## TECHNICAL BULLETIN:

### 360 CHAINROLL - 600 EARLY M6 REWORK

FIGURE 1

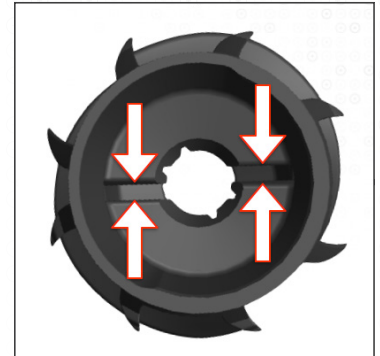
Historically the 600 early series corn heads have had issues with the shaft splines shearing off over the lifetime of the stalkroll. The clamp design on the 600 early series 360 CHAINROLL compresses around the shaft and removes the possibility of "chatter" between the 360 CHAINROLL and the shaft. The chatter can occur during operation should the front nut become loose or be improperly torqued.

FIGURE 2

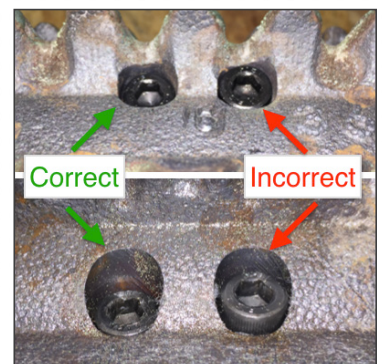
- + Final torque (17ft/lbs) is achieved before the M6 is properly seated as pictured in the far right of *FIGURE 2*.

- The images at far left of *FIGURE 2* show the M6 cap screws when they are properly seated and torqued. This is critical to providing a reliable clamping force to the shaft.
- If rolls are installed, visually check the counter sunk depth of the M6 cap screw to ensure that it is making contact with the casting.
- Final torque should not be achieved until after the M6 cap screw is properly seated.

If the issue exists, rework will be required. See rework instruction steps on next page.
